addendum no. three

OWASSO PUBLIC SCHOOLS
Owasso 8th Grade Addition

Architect: The Stacy Group
Project Number: 2407

03.26.2026

A Retaining Wall A - Plan

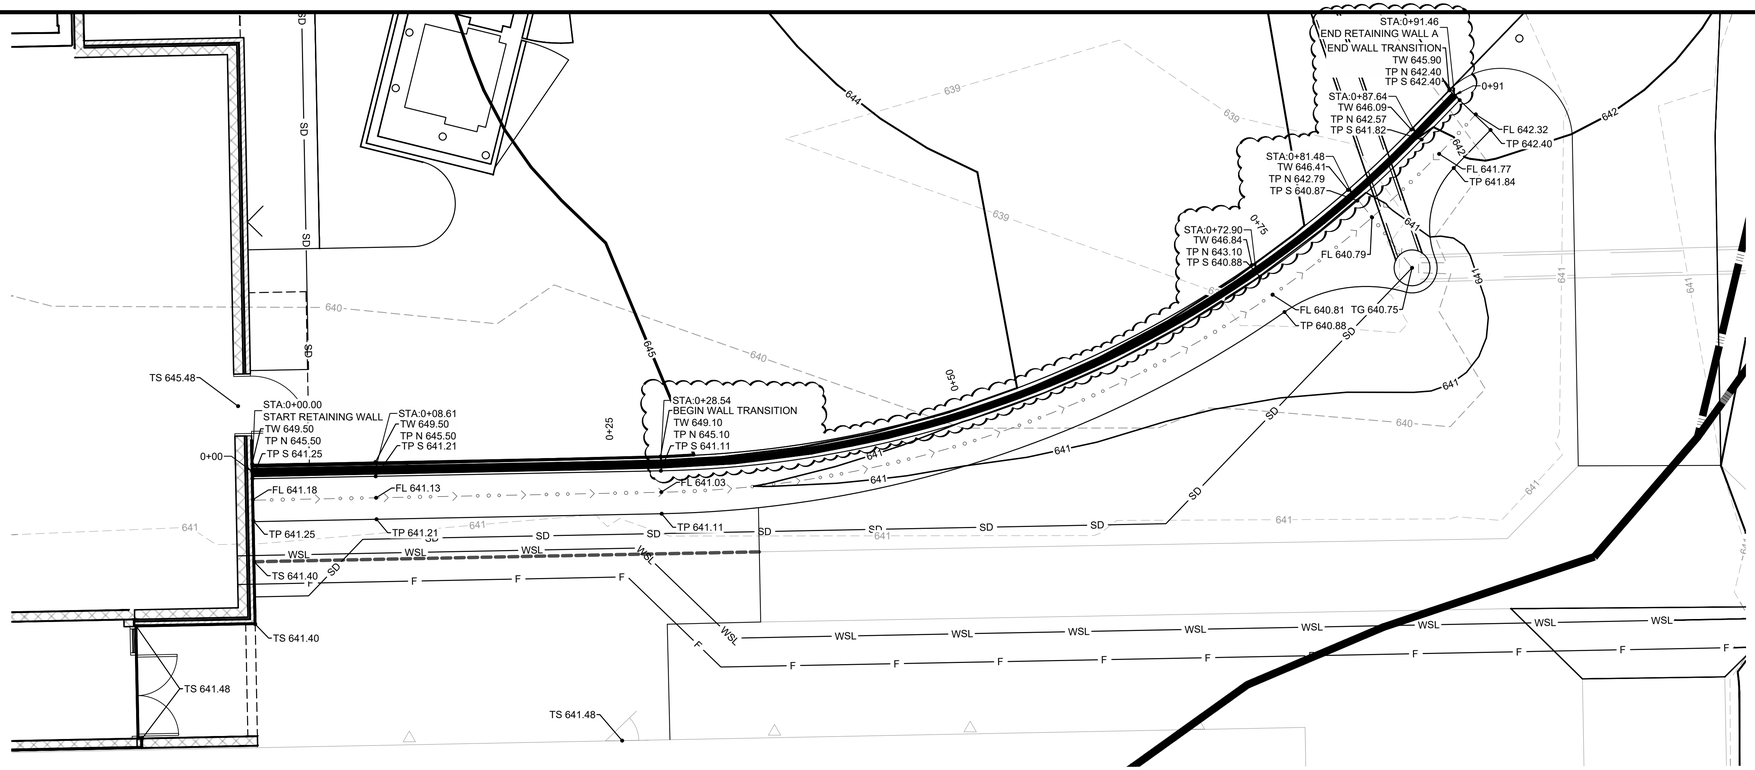
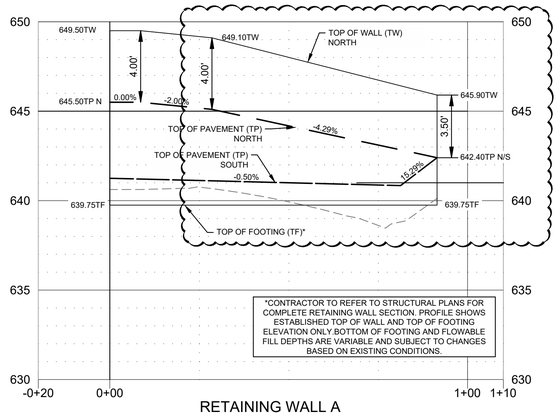
A3-9 Sheet C301 Retaining Wall Plan:
- Wall raised from 24" to 42" at east.
- Grades adjusted where applicable for the raised wall.

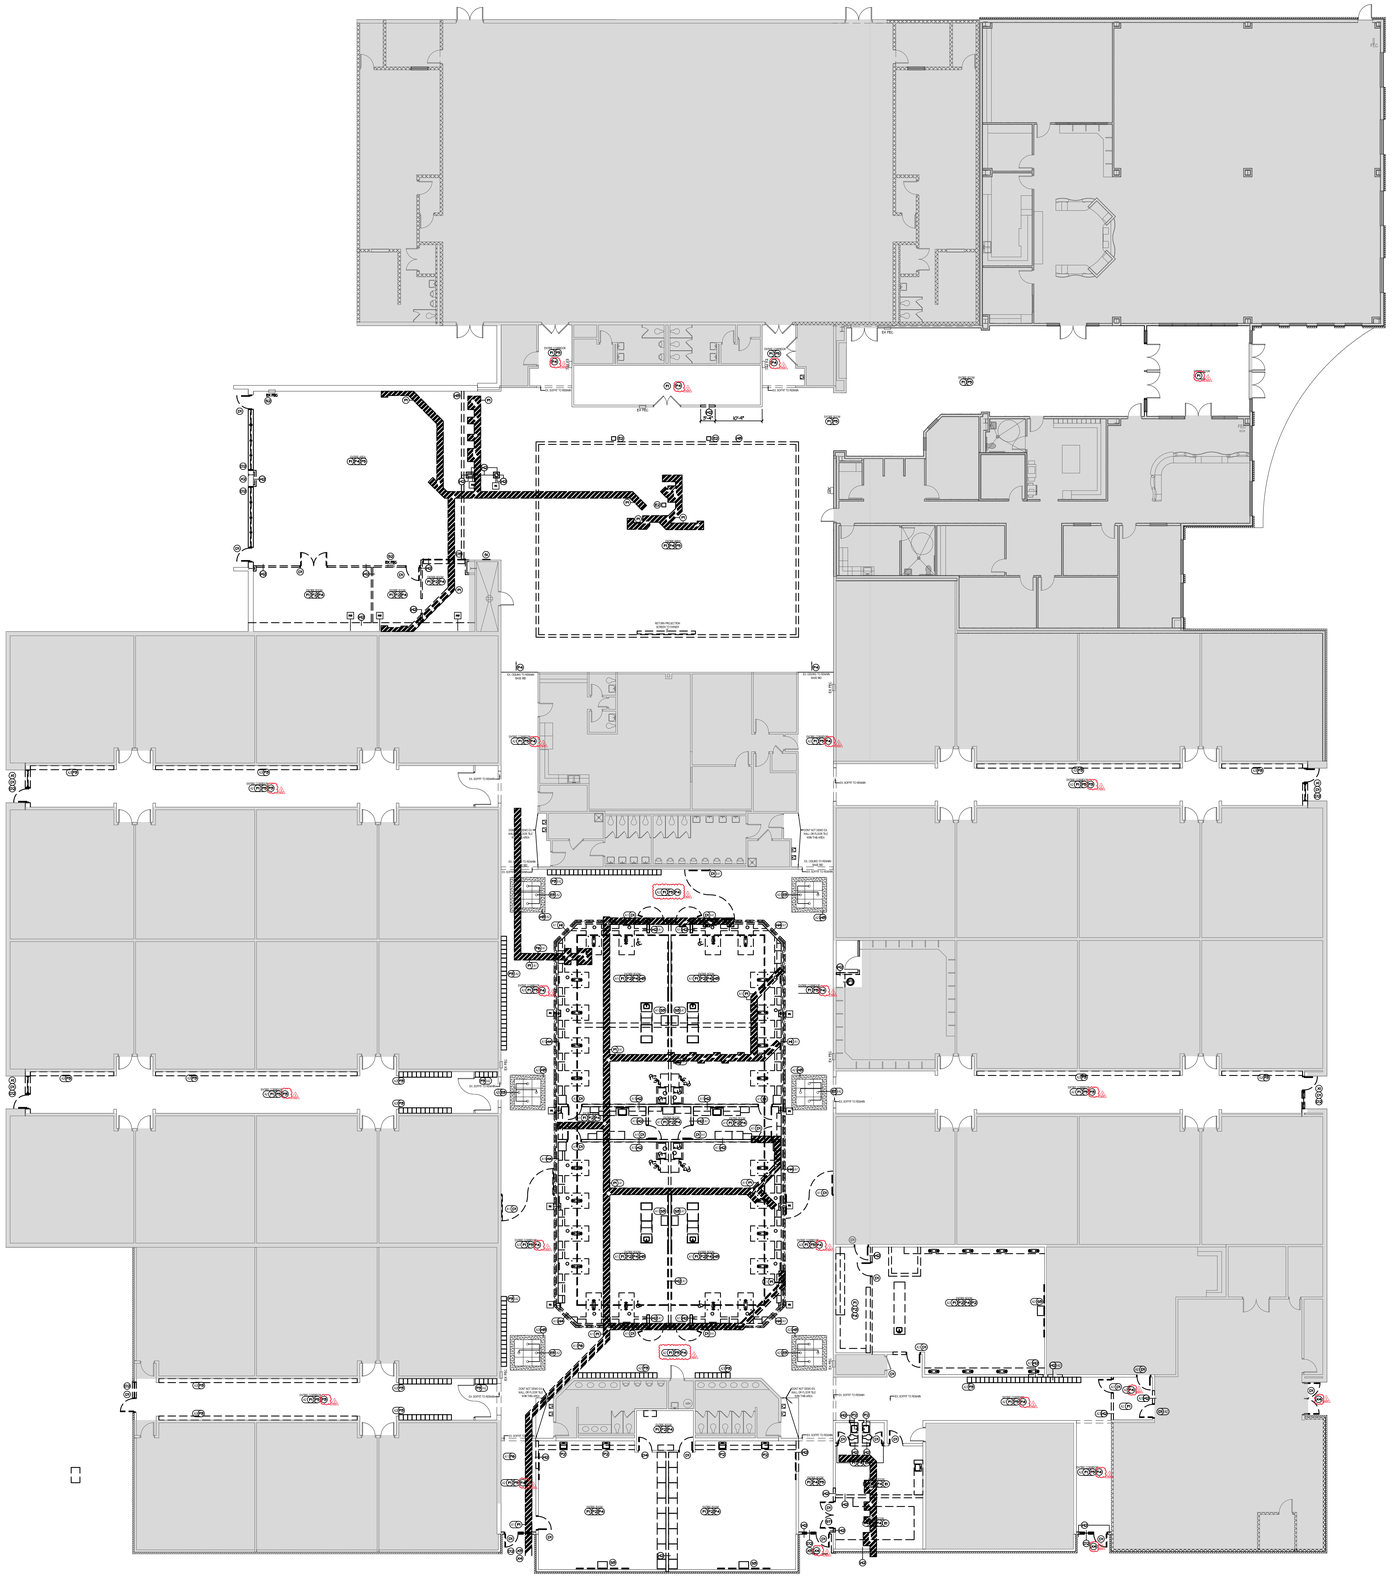
A3-22 Sheet D100 Overall Demo Plan: Add Demolition Keynote Legend. Replace sheet in its entirety.

11 FLOOR PLAN - AREA 1
SCALE: 1/8" = 1'-0"

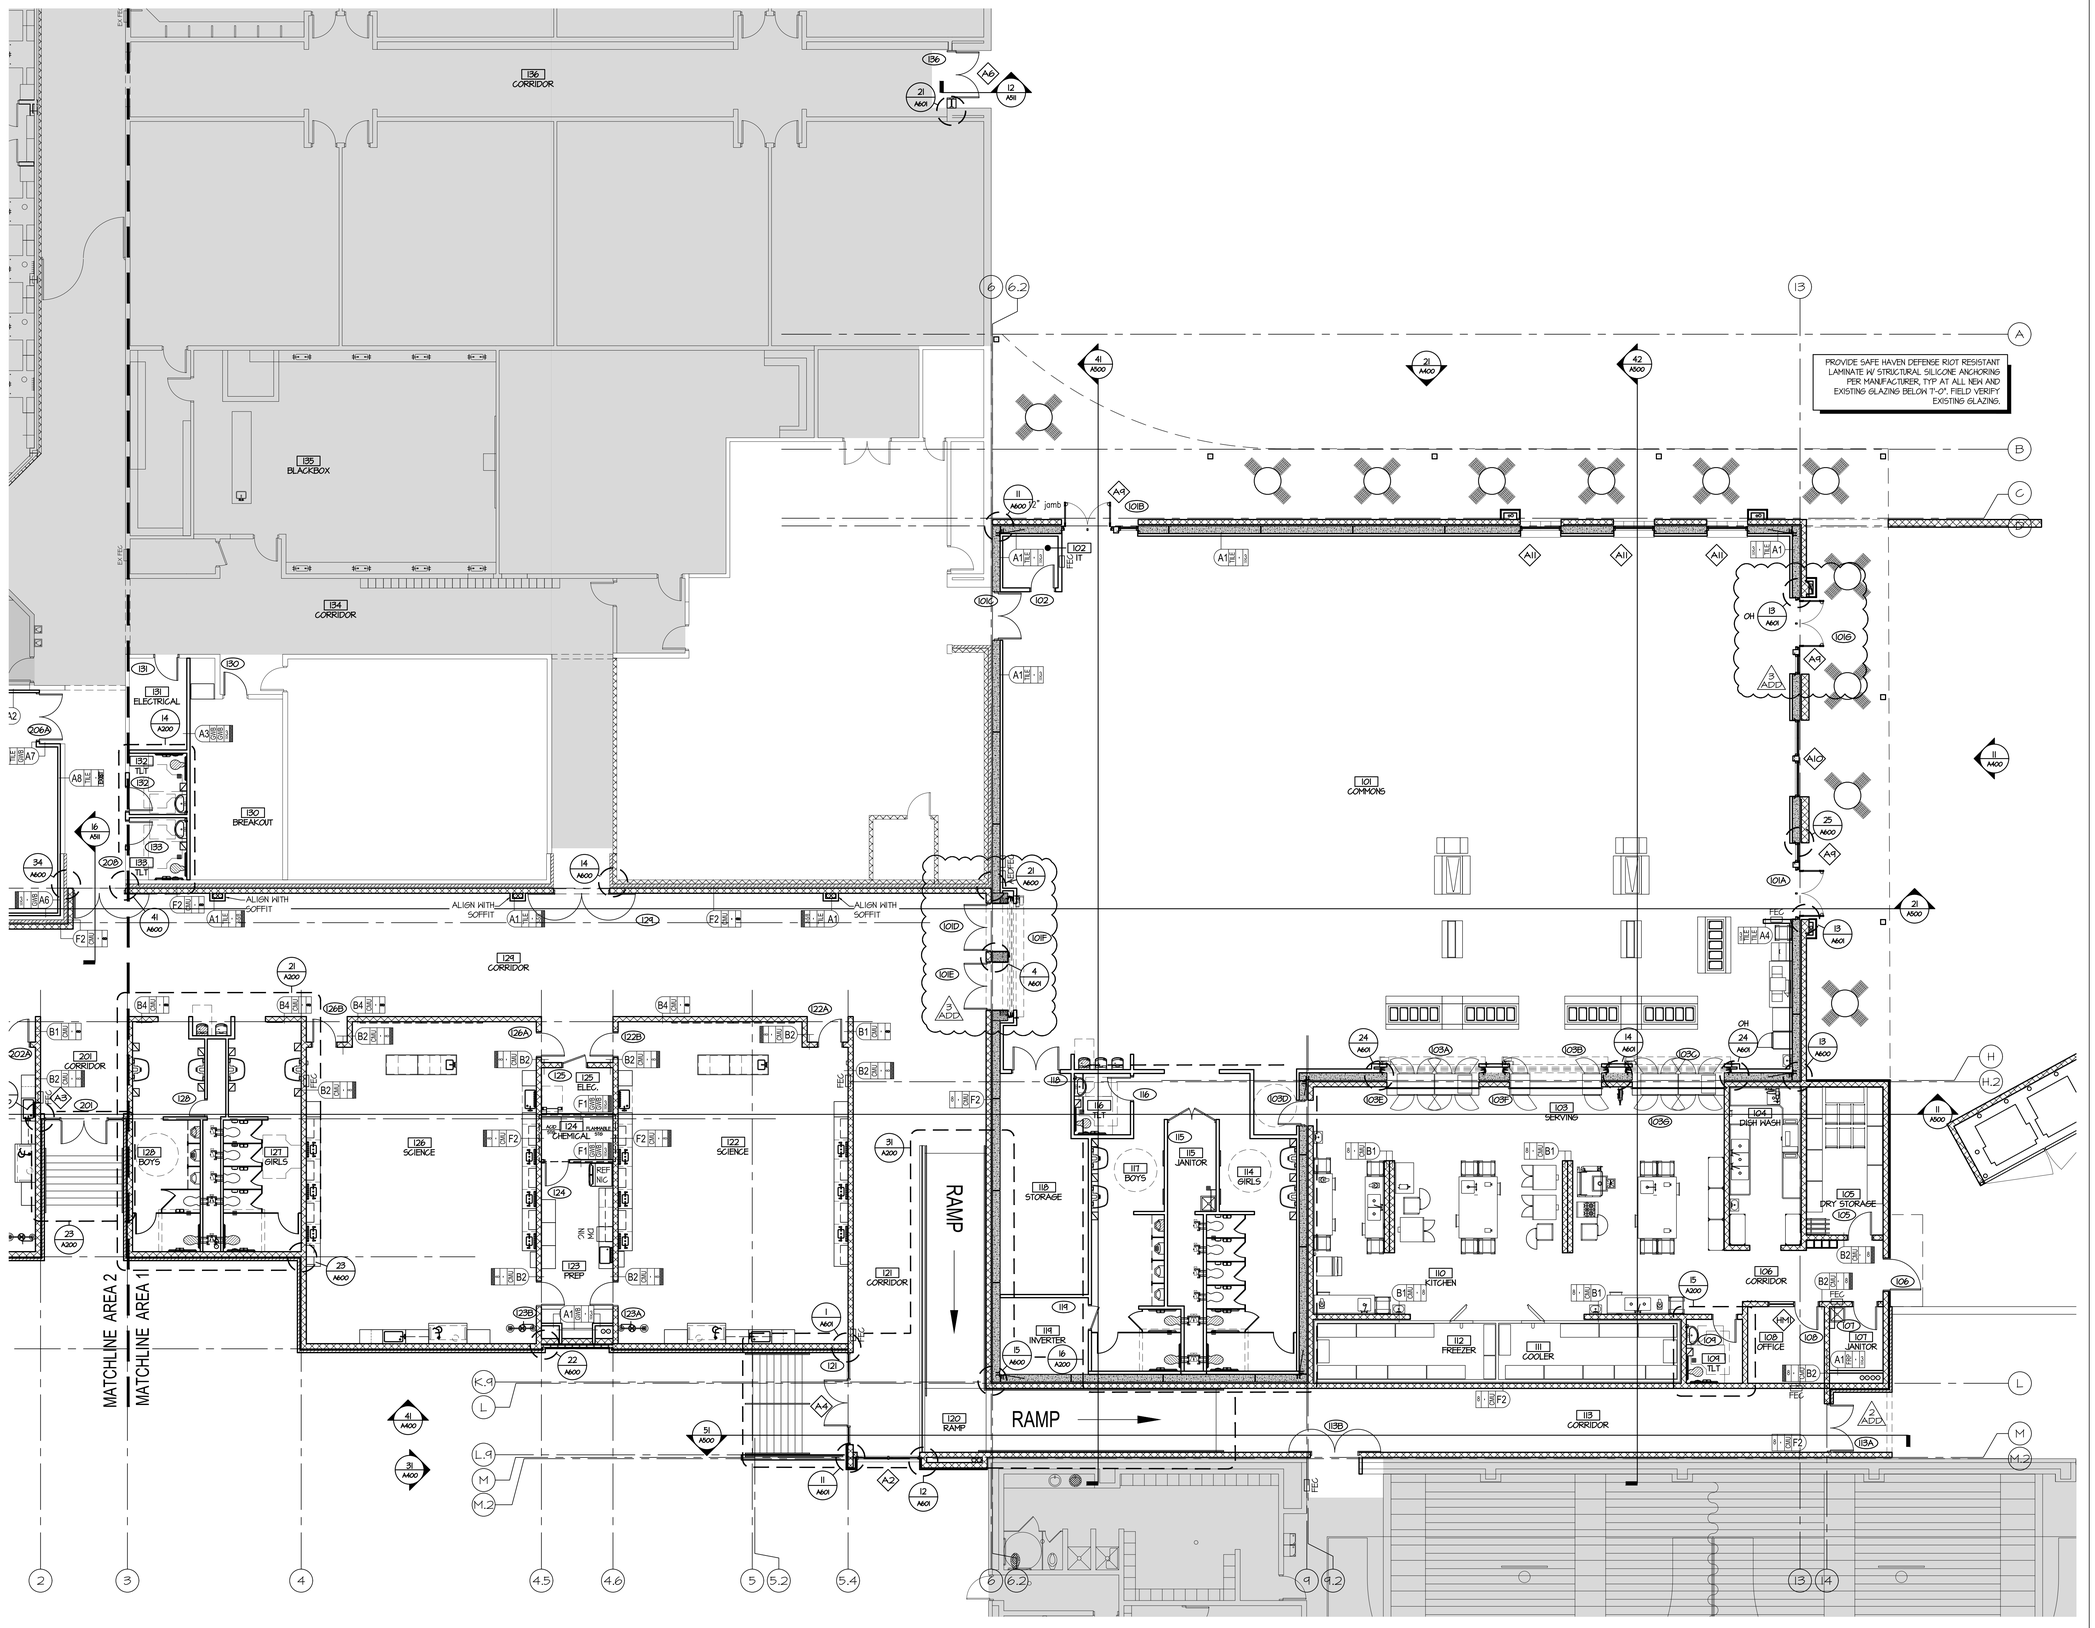
A3-23 Sheet A101 Floor Plan Area 1 – Reference: Revise door openings. Replace sheet in its entirety.

11 FLOOR PLAN - AREA 3
SCALE: 1/8" = 1'-0"

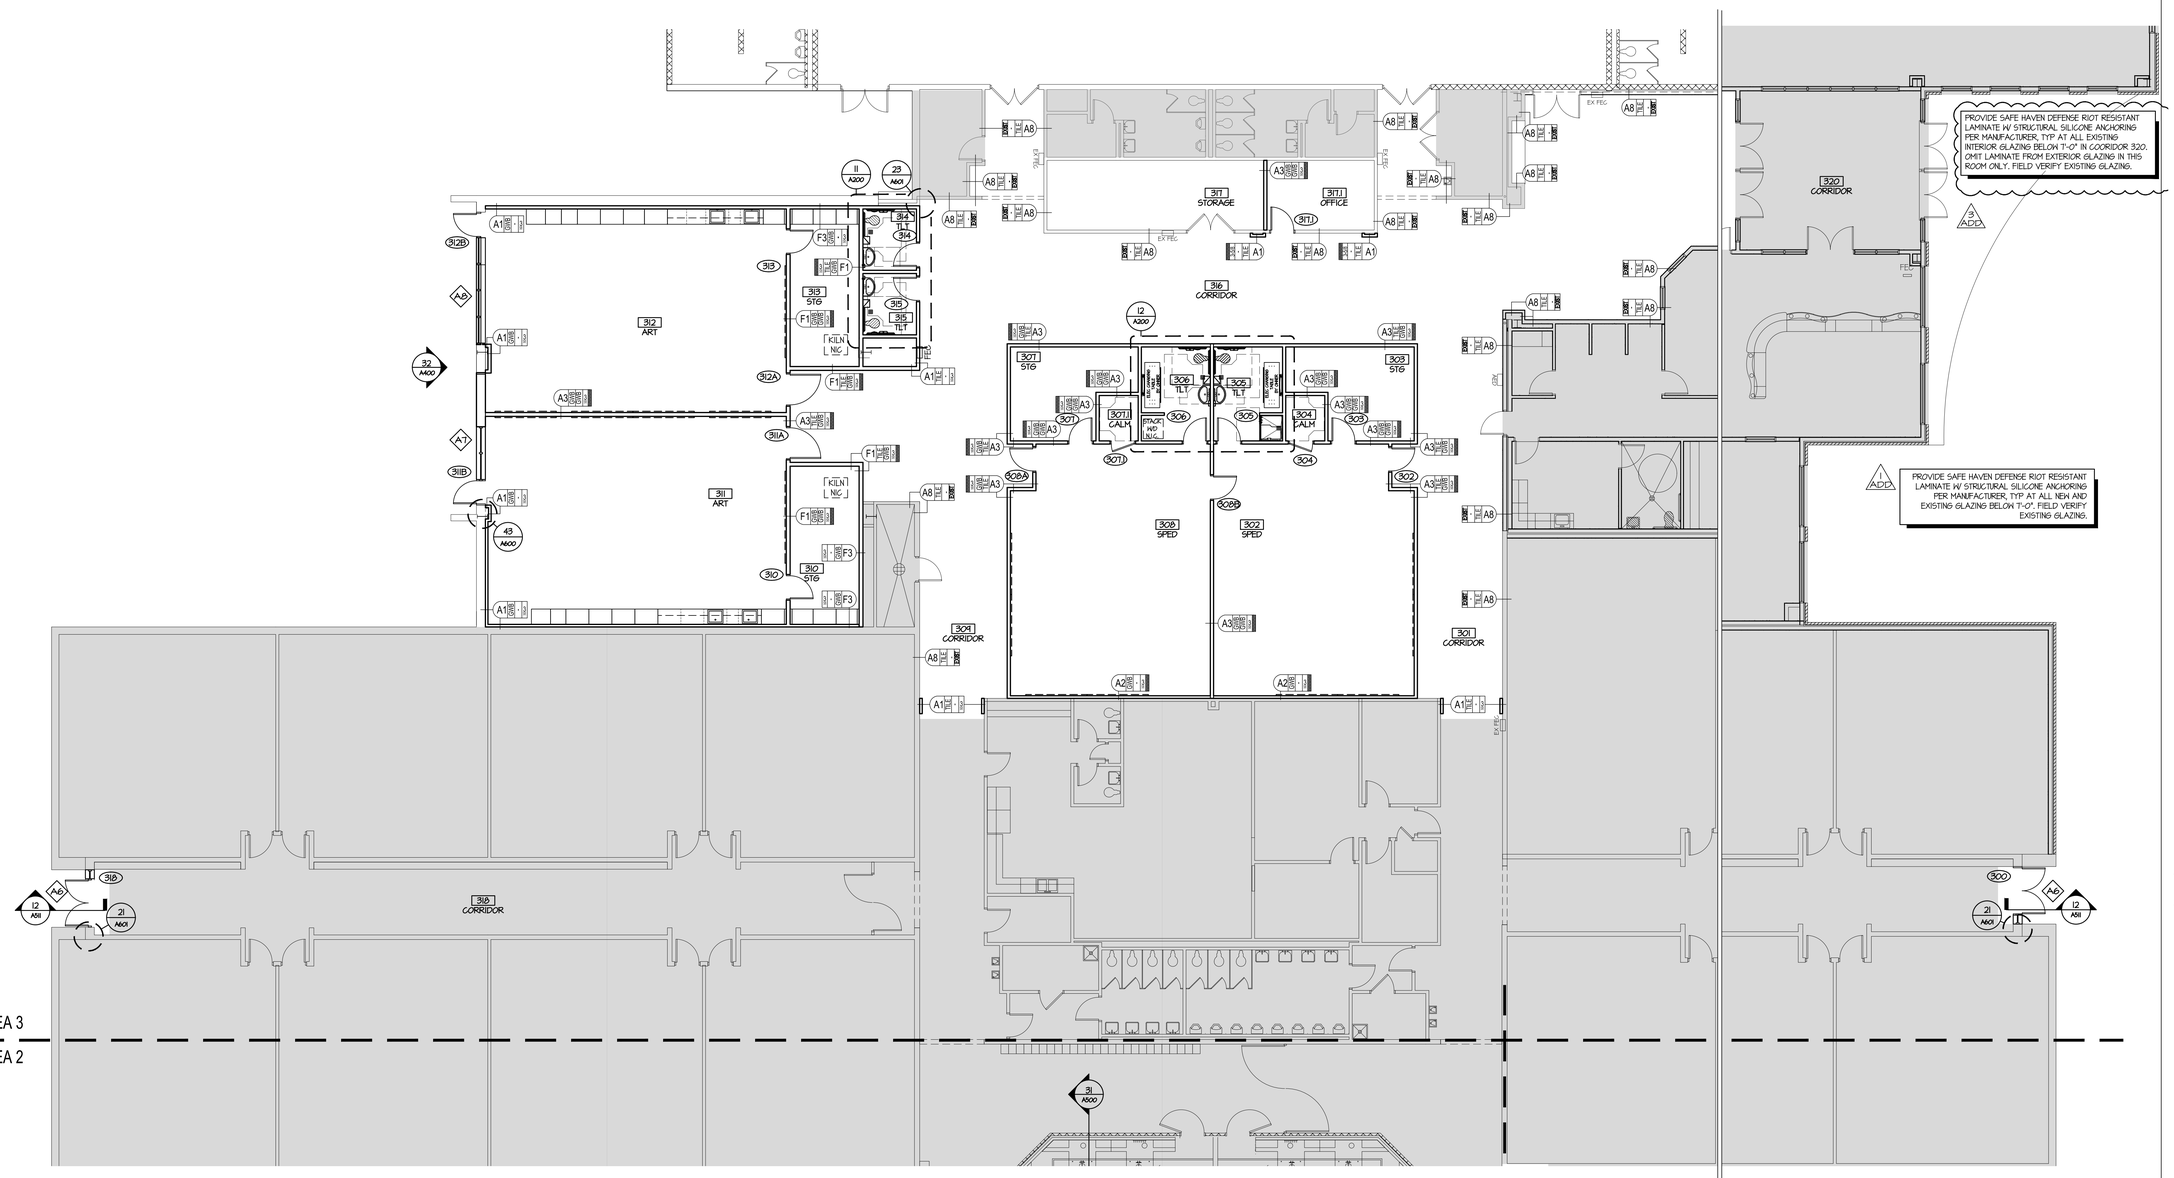
A3-24 Sheet A103 Floor Plan Area 3 – Reference: Revise security film note at secure vestibule. Replace sheet in its entirety.
